TORQUE TUBE TALE

Dear Windy,
Fig 5-18, page 5-47, TM 55-1520-228-20 (Oct 72) gives damage limits for the torque tube assembly.

AREA A

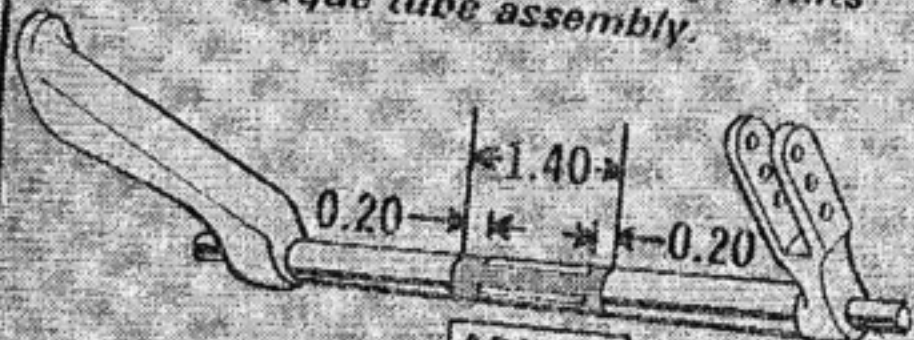
Area A in this figure is to be FREE of dents. Does this mean we should replace the tube assembly for any damage to that area, no matter how small?

It sure does. NO rework is allowed in this area. Any visible twisting or denting of the slotted portion of the tube means that it's been subjected to excessive loads and should be replaced.
